**ADDENDA
00 91 13**

Mechanical Addendum #M-01

The information listed below is to form part of the Contract Documents. All associated costs are to be included in the Bid Price shown on the Bid Form. Acknowledgment of this Addendum, by number, is to be shown in the space provided on the Bid Form.

M1-06

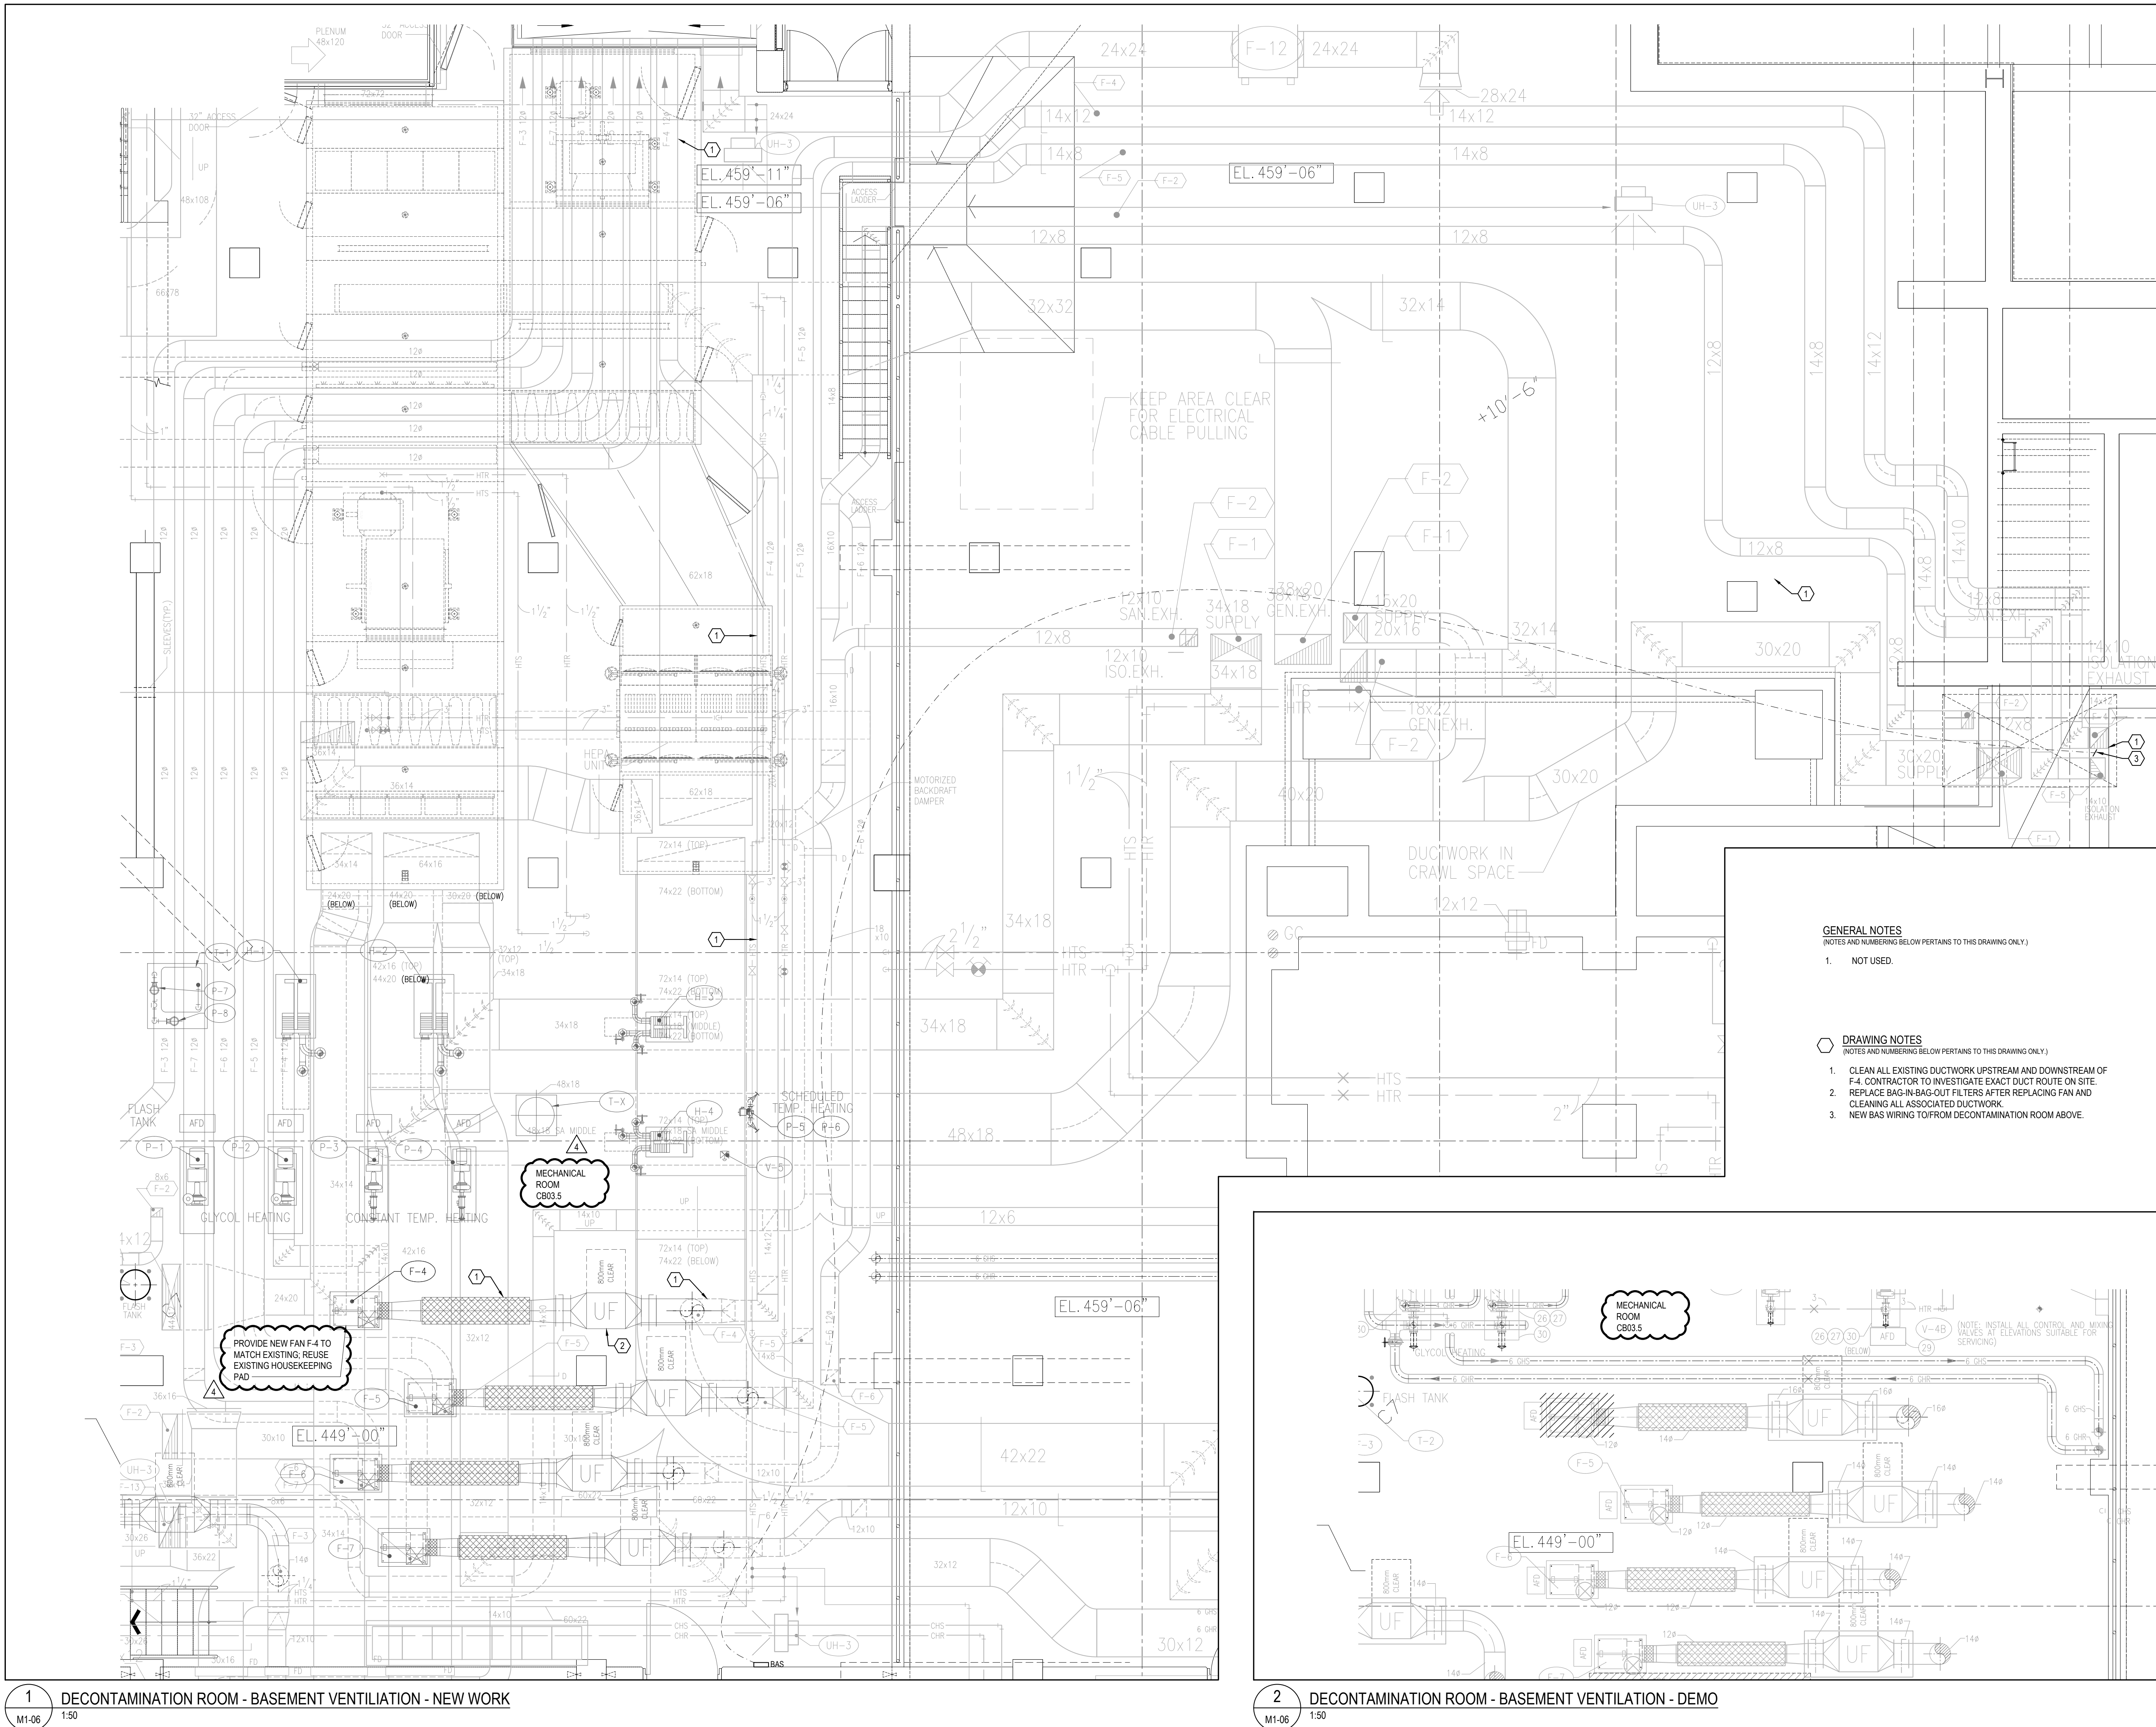
- 2) Are we providing housekeeping pad for exhaust fan? If yes, what is pad size and re-bar details? Is ready mix concrete required or hand mix concrete?

3.8 Reference Drawing M1-06 DECONTAMINATION ROOM - BASEMENT VENTILATION (reissued)

- .1 Note "REUSE EXISTING HOUSEKEEPING PAD" shown on drawing to clarify scope.
- .2 Showed Room Name & Room No for clarity: "MECHANICAL ROOM CB03.5".

ANSWER: Reuse existing housekeeping pad. Note added to Drawing M1-06 as part of this addendum for clarity.

Sheet Name
**MEDICATION ROOM -
BASEMENT
PLUMBING - DEMO &
NEW WORK**

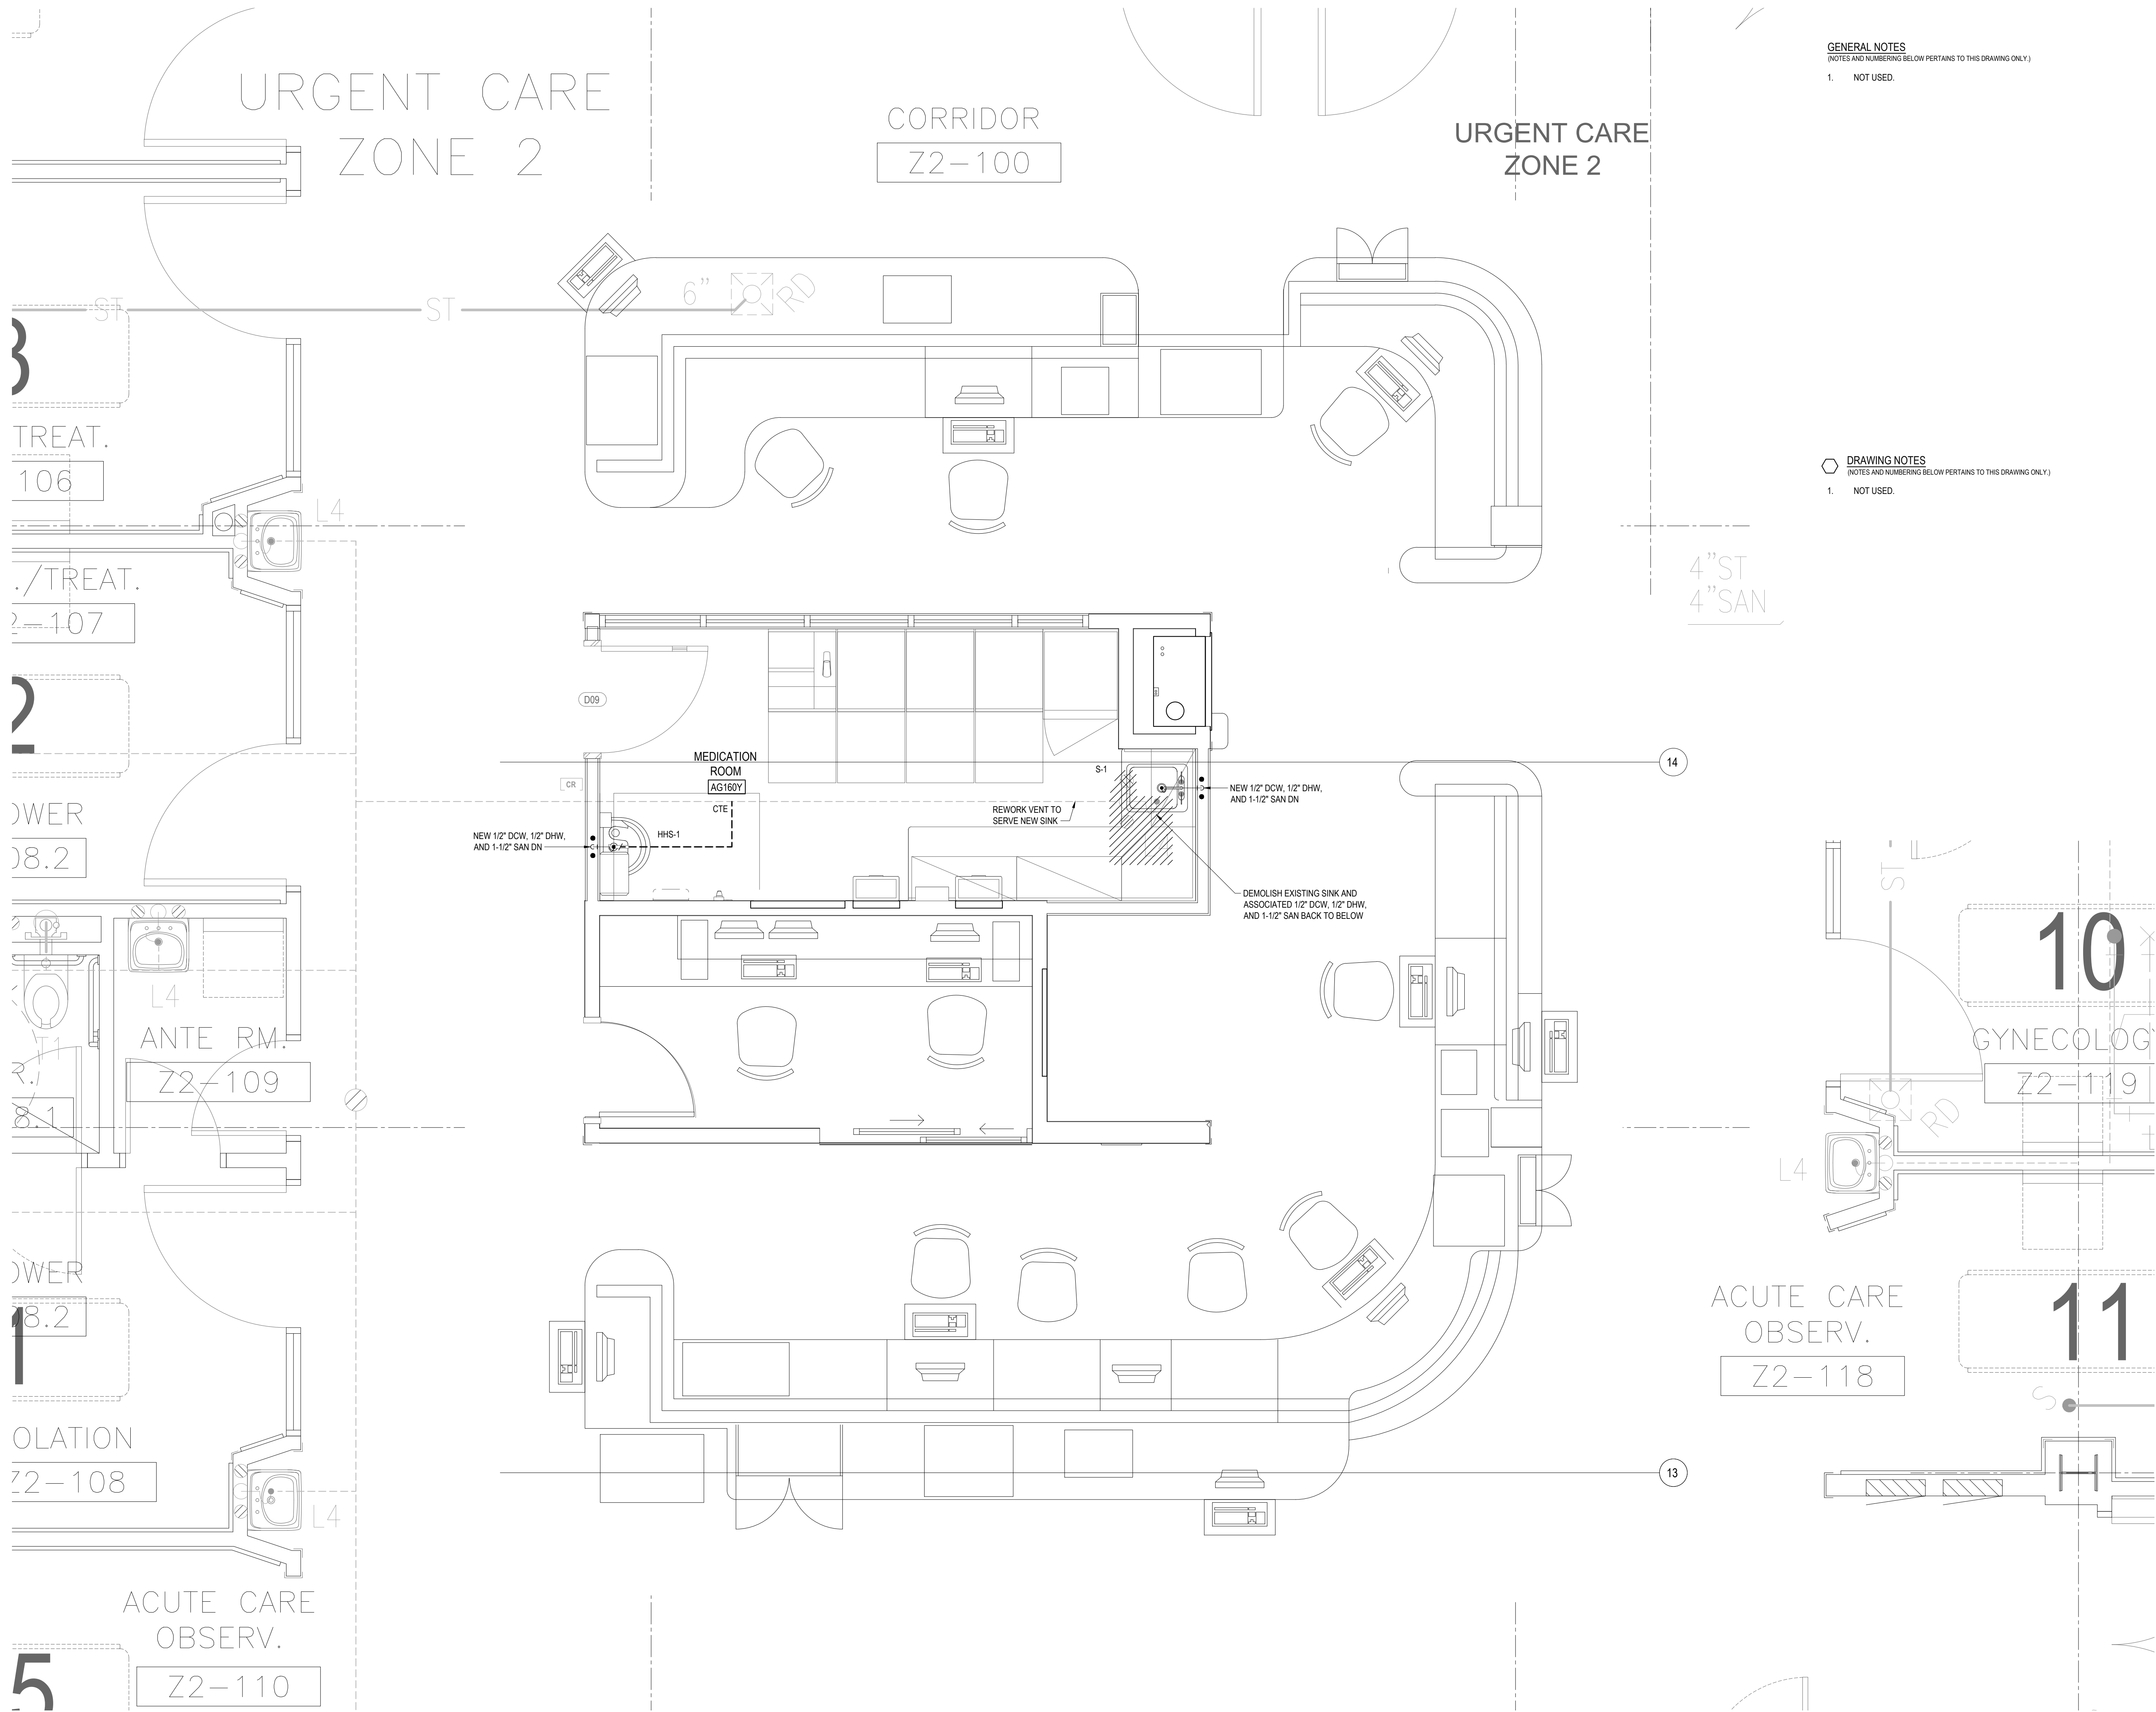
3.10 Reference Drawing M3-00 MEDICATION ROOM - BASEMENT PLUMBING - DEMO & NEW WORK (reissued)

- .1 Showed Room Name & Room No for clarity: "MECHANICAL ROOM CB03.5".
